pitt&sherry

20 August 2019

Re: Development Application for Inveresk Pedestrian Bridge DA0312/2019 – Request for further information

Figure 1 Northern steps clearance diagrams

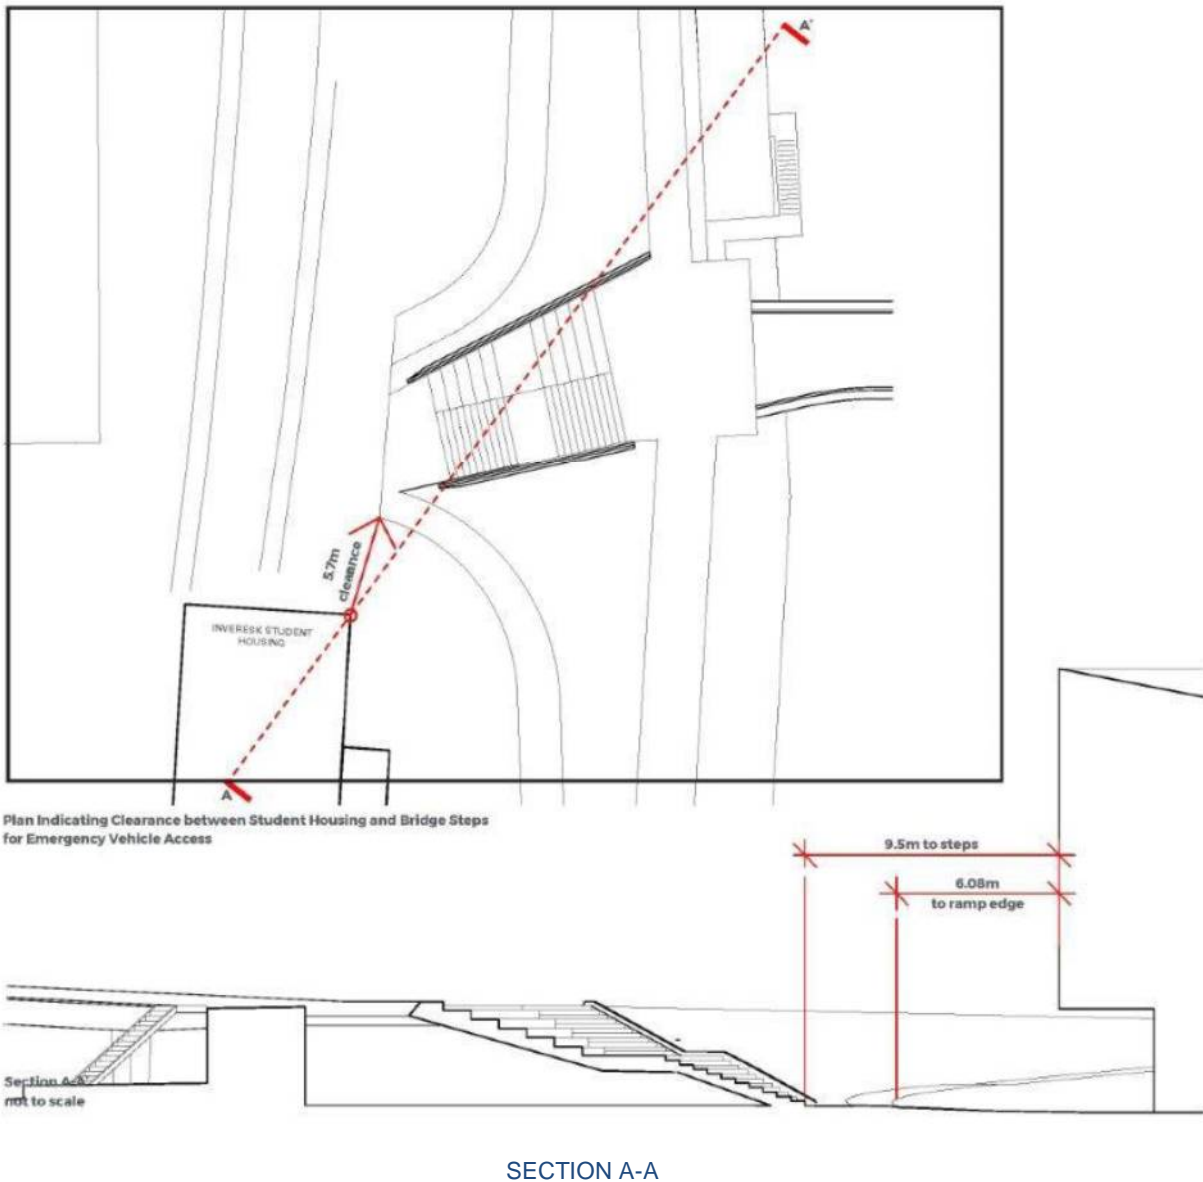
The LFA require explanation as to why this alignment alteration to the west has been chosen where from a flood levee maintenance perspective, an alignment to the east or straight off the bridge would be more appropriate. The applicant be asked to provide a cross section through the building and the steps at its minimum clearance alignment

The alignment alteration of the northern steps slightly to the west is to connect directly to the future pedestrian spine into the heart of the campus. This will form an important component of the overall Northern Transformation Project Masterplan.

See below a plan and cross section showing available clearance for emergency vehicles:
